ATTACHMENT A

Specifications for the
Bentonite Slurry Cutoff Trench
Proposed for the Evaporation Pond

Conoco Inc.
Sand Rock Mill Project
Docket No. 40-8743

FIGURE 4-7 WATER LEVEL ELEVATION IN THE 7D SAND AQUIFER FOR JANUARY, 1980

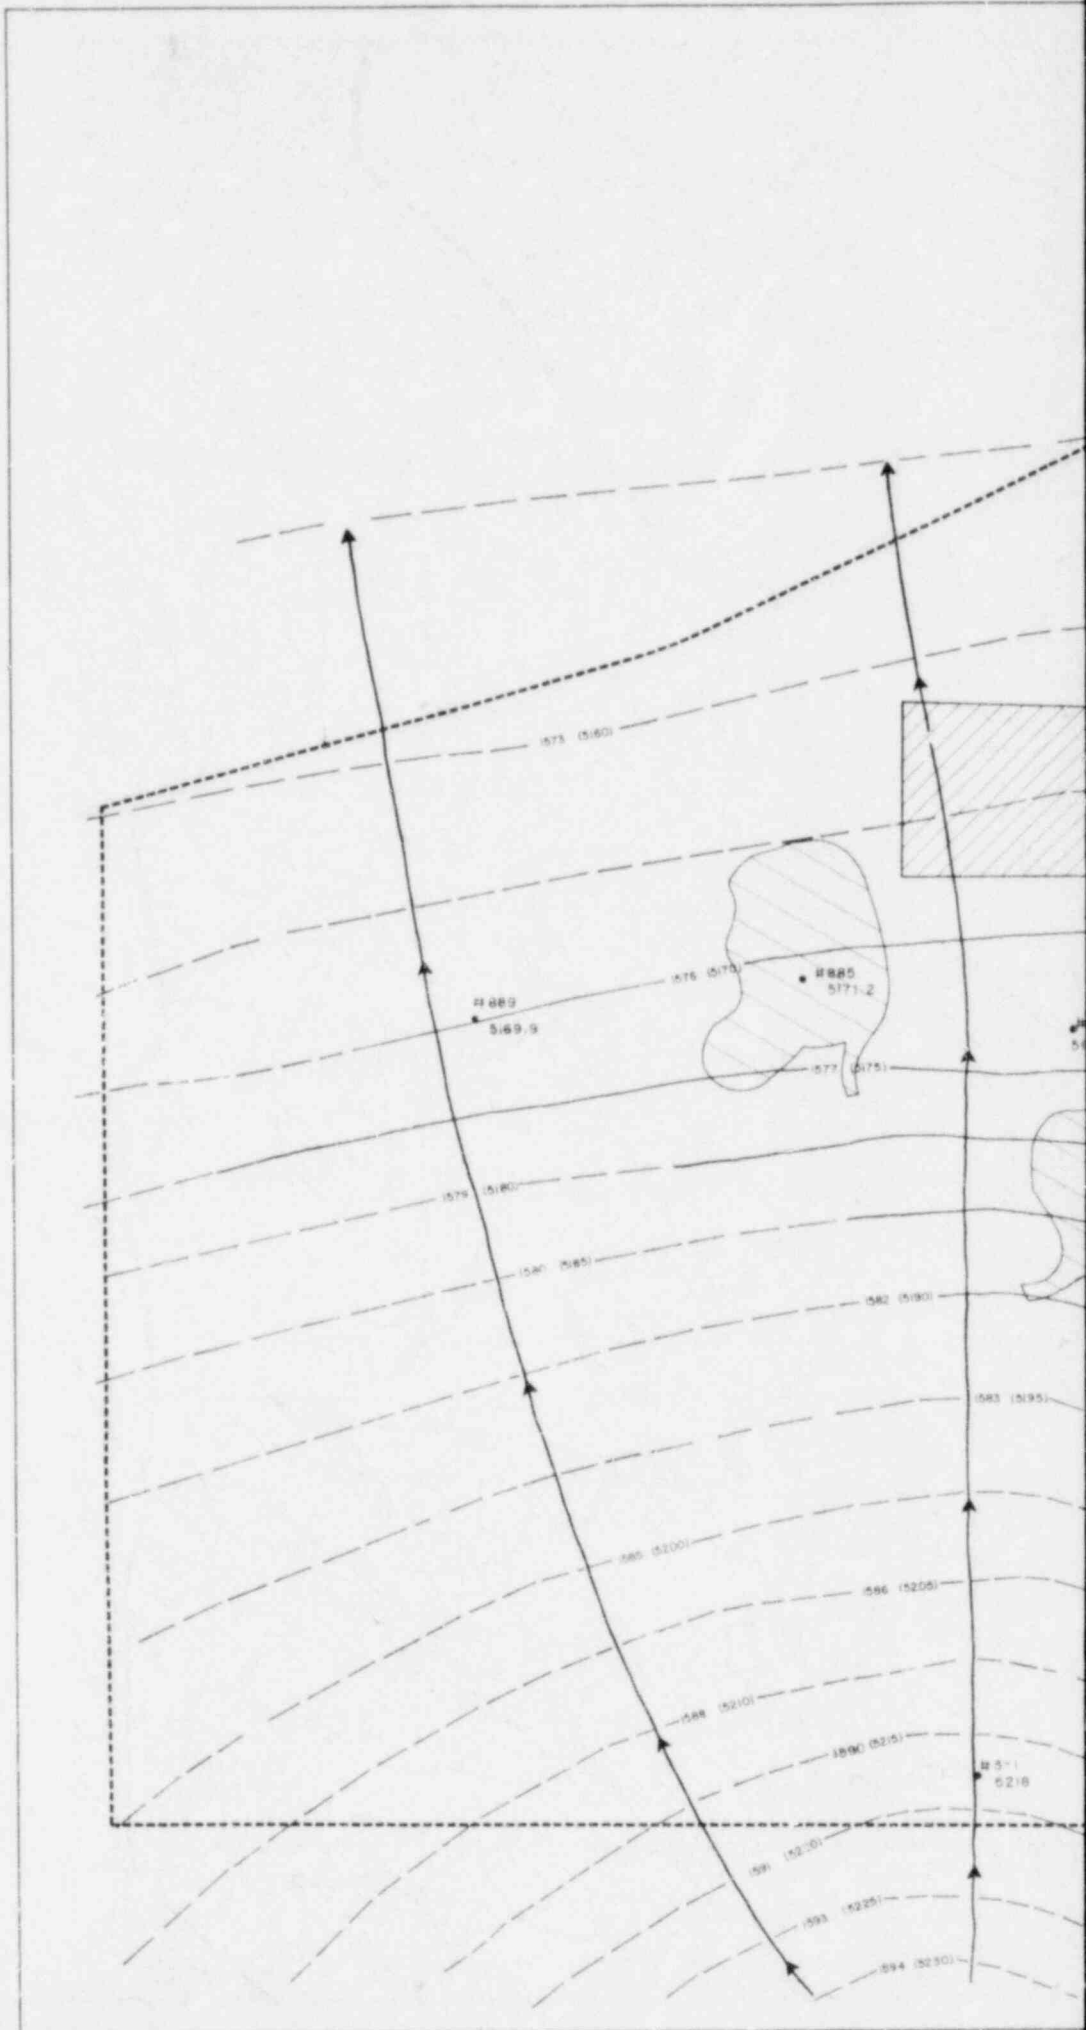
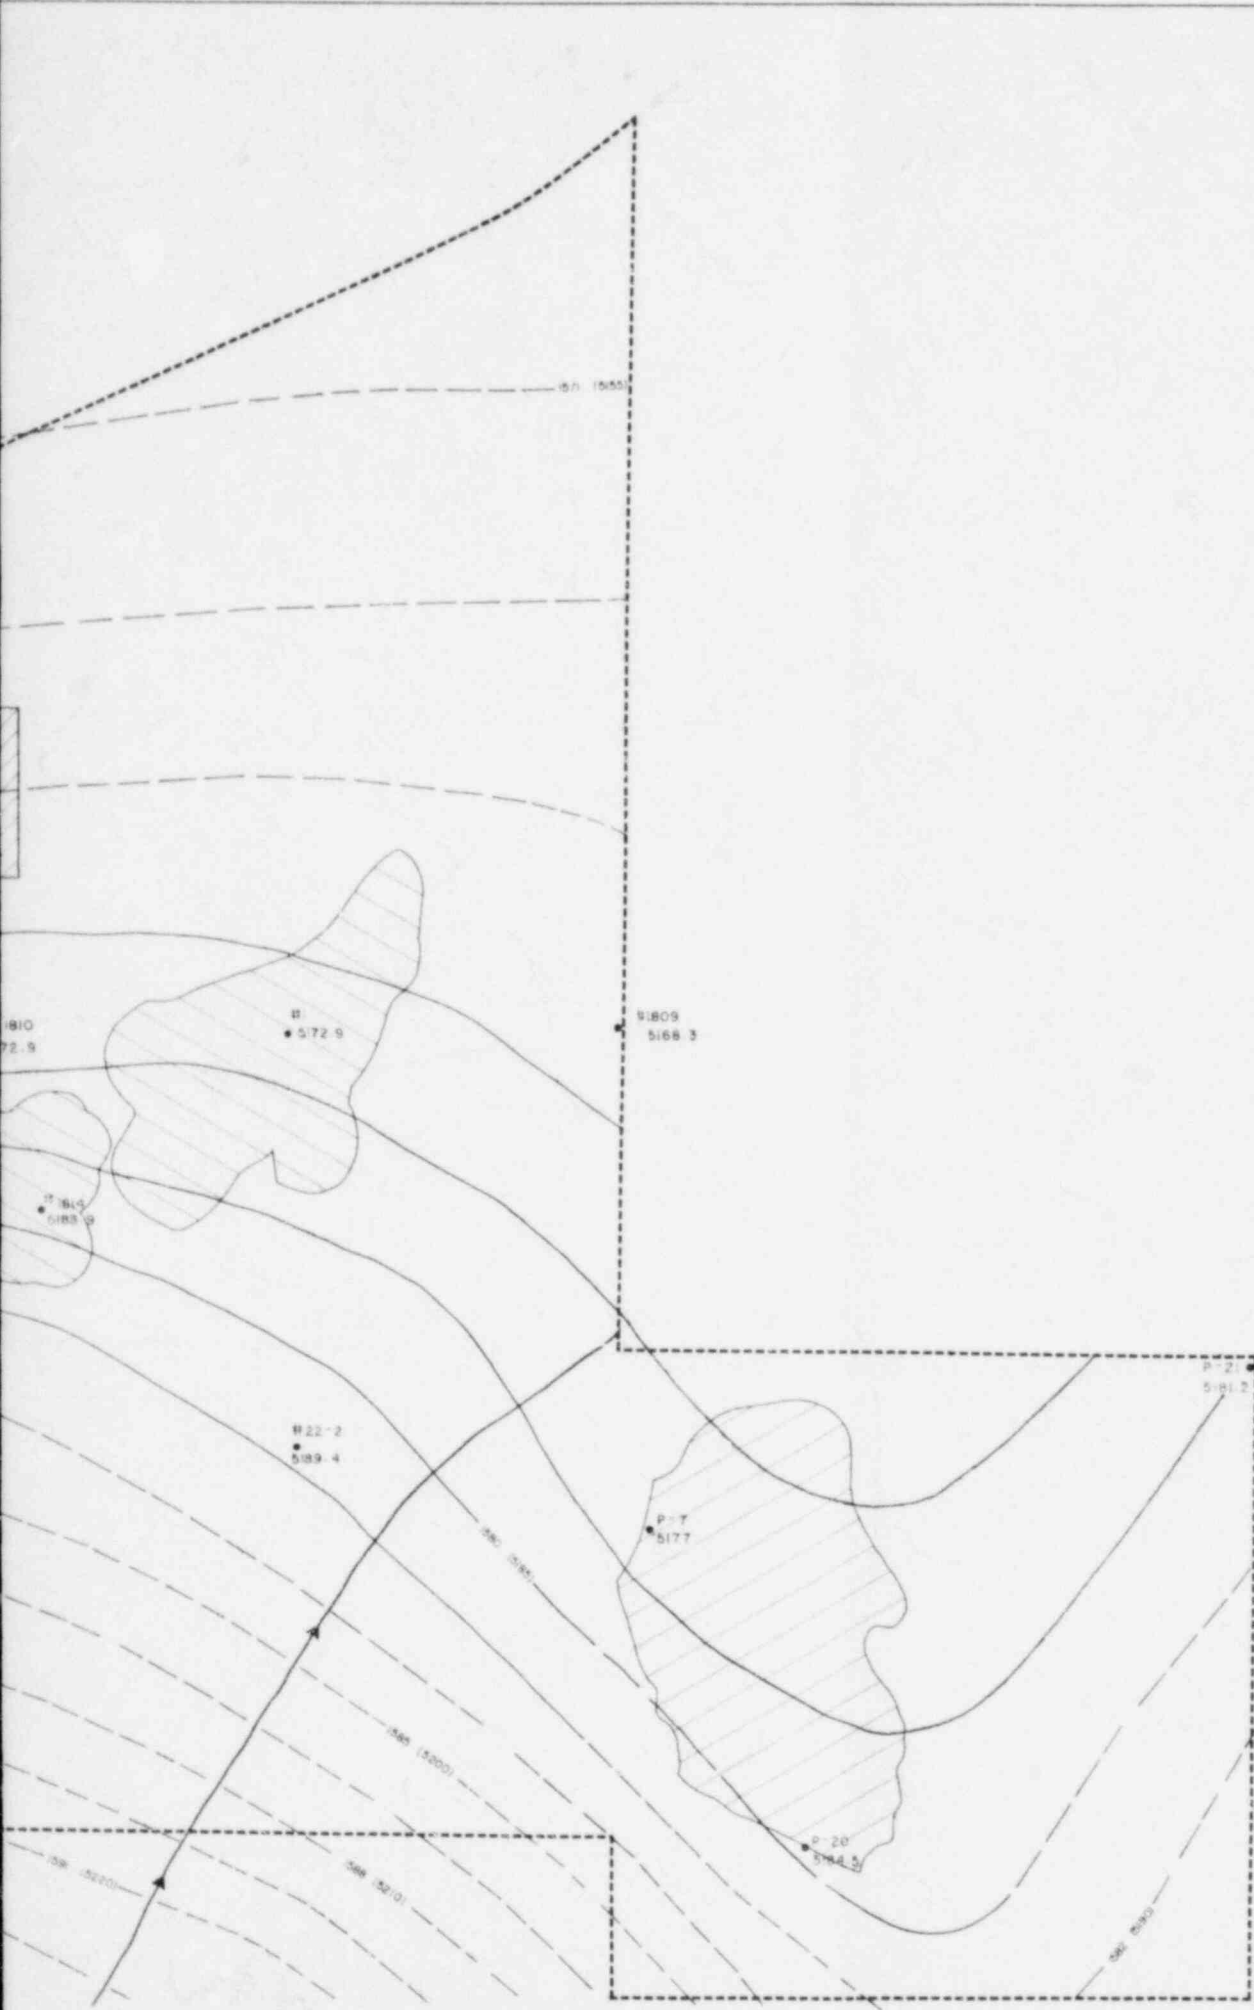
7. Revise ER Figure 2.7-4, "70 Sand Water Table". Show the flow direction, and rate of flow.

The attached Figure 2.7-4 has been revised to remove the 70 sand water table elevation contours that were interpreted beyond the permit boundary and beyond the range of verifying wells. The groundwater flow lines were also checked to follow the steepest gradient.

Values for average gradient, permeability and groundwater movement are presented in Sand Rock Mill ER Section 2.7.1.6 Water Movement, page 2-110.
